Intersection ID: 13966	Main Street: FAULCONBRIDGE_RD	Cross Street: HOLLIROSE_DR	Location:	NW
ADA ID: 20B7E25FA913	Ramp Type: BlendTrans1	Initial Pass/Fail: Fail	Overall Compliance: No	Severity Score: 8.75

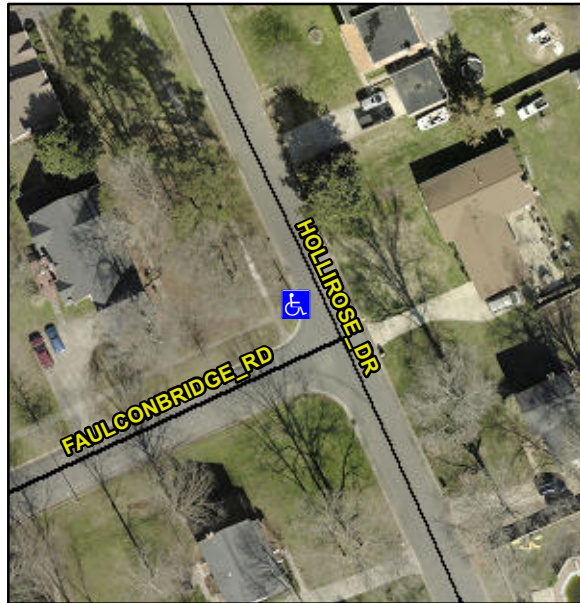
Not Found, R304.5.1

Compliance	Description	Data	Compliance	Description	Data
N/A	Ramp Length (in)	59.0	Yes	BlendTrans Slope (%)	3.0
No	Ramp Width (in)	47.0	Yes	BlendTrans XSlope (%)	0.2
N/A	Flare Type LT	N/A	N/A	Flare Type RT	N/A
N/A	Flare Slope LT (%)	N/A	N/A	Flare Slope RT (%)	N/A
N/A	Flare Traversable LT?	N/A	N/A	Flare Traversable RT?	N/A
N/A	Landing Length (in)	N/A	N/A	DWS Provided?	N/A
N/A	Landing Width (in)	N/A	N/A	DWS Contrast?	N/A
N/A	Landing Slope (%)	N/A	N/A	DWS Length (in)	N/A
N/A	Landing X Slope (%)	N/A	N/A	DWS Full Width?	N/A
N/A	Landing Curb? (Y/N)	N/A	N/A	DWS Offset (in)	N/A
N/A	Shared Landing?	N/A			
N/A	Gutter Ponding?	N/A	N/A	Gutter Slope (%)	N/A
N/A	Gutter Lip Ht (in)	N/A	N/A	Gutter X Slope (%)	N/A
N/A	Painted X Walk1?	No	N/A	Painted X Walk2?	N/A
	X Walk 1 Direction	To E		X Walk 2 Direction	N/A
	X Walk 1 Width (in)	N/A		X Walk 2 Width (in)	N/A
	X Walk 1 Slope (%)	4.9		X Walk 2 Slope (%)	N/A
	X Walk 1 X Slope (%)	0.8		X Walk 2 X Slope (%)	N/A

N/A	Ramp inside XWalk1?	N/A	N/A	Ramp inside XWalk2?	N/A
	Road Slope (%)	0.8		Clear Space?	N/A
	Road X Slope (%)	4.9	N/A	Clear Space to XWalk (in)	N/A
N/A	Any Obstructions?	N/A	N/A	Storm Grate/Utility Hazard?	N/A
	Obstruction Type			Storm Grate/Utility Type	
		N/A			N/A
			Yes	Surface Condition? (G/P)	Good
			No	Curb Slope (%)	14.0

Remove & Replace Curb Ramp With Two New Directional Ramps or Equivalent.
